## PUBLIC INTEREST REVIEW FOR GROUNDWATER APPLICATIONS

TO:		Water	Rights S	ection	Date										
FROM:	M: Groundwater Section														
SUBJE	JBJECT: Application G- 18175					Reviewer's Name Supersedes review of									
OAR 69 welfare, to determ	<b>90-310-1</b> safety and mine when	30 (1) T nd healt ether the	The Departs  th as describe  presumpt	MPTION; ment shall p ibed in ORS ion is establ ew is based	resume that 537.525. D ished. OAR	t a propose epartment . 690-310-	ed ground staff rev 140 allov	iew g vs the	groundwate e proposed	r applica use be m	e prese tions u	ervation on Inder OAl	f the pub R 690-31 tioned to	0-140 meet

A. <u>GEN</u>	NERAL	INFO	RMATI(	<u>ON</u> : A	pplicant's N	Name:	Elite So	il, L	LC		(	County: _	Deschu	tes	
A1.	Applica	nt(s) see	ek(s) <u>0.5</u>	cfs from	m <u>1</u>	well(	(s) in the		Deschutes	6				_Basin,	
	]	Lower (	Crooked			subb	asin (Alfa	alfa q	uad)						
A2.	Propose	d use _	nu	rsery, com	mercial	Seas	sonality:	yea	r round						
A3.	Well an	d aquife	er data ( <b>att</b>	ach and nu	mber logs f	for existin	g wells;	mark	k proposed	wells as	such	under log	gid):		
Well	Logid DESC 60299		Applicant Well #	Propos	Proposed Aquifer*  Deschutes Fm		Pro

### Water-Level Trends in Nearby Wells

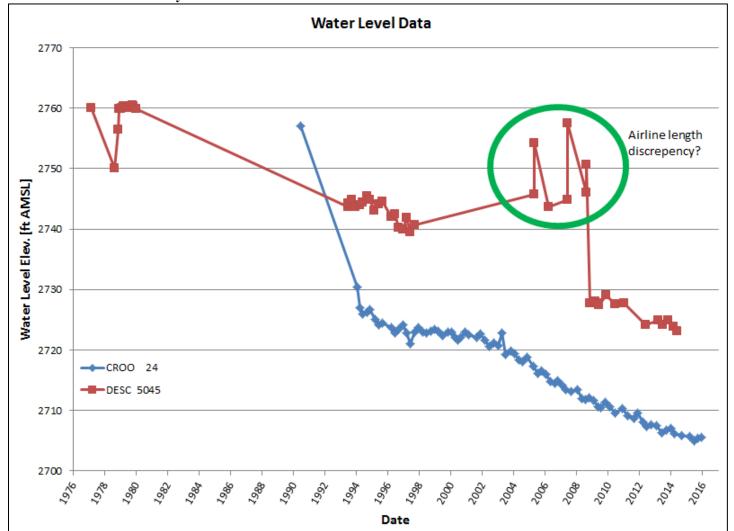
a.	Condition to allow groundwater production from no deeper than ft. below land surface;								
٠.	Condition to allow groundwater production from no shallower than ft. below land surface;								
	Condition to allow groundwater production only from the groundwater reservoir between approximately ft. and ft. below land surface;								
! <b>.</b>	<ul> <li>■ Well reconstruction is necessary to accomplish one or more of the above conditions. The problems that are likely to occur with this use and without reconstructing are cited below. Without reconstruction, I recommend withholding issuance of the permit until evidence of well reconstruction is filed with the Department and approved by the Groundwater Section.</li> <li>Describe injury —as related to water availability—that is likely to occur without well reconstruction (interference w/</li> </ul>								
The We	oundwater availability remarks:  ore are no nearby State Observation wells. The nearest State Observation Wells with a likely similar response are Observation (CROO 24, located approximately 11.8 miles to the north), and Obs Well 1365 (DESC 5045, located roximately 11.9 miles to the west). These wells have been monitored periodically since at least the mid 1990's. Both wells

w a decline from the start of measurement until present. This trend is coincident with climate cycles. Since the mid 0's, the water levels have dropped ~21-23 feet, likely mostly as a result of decreased recharge.
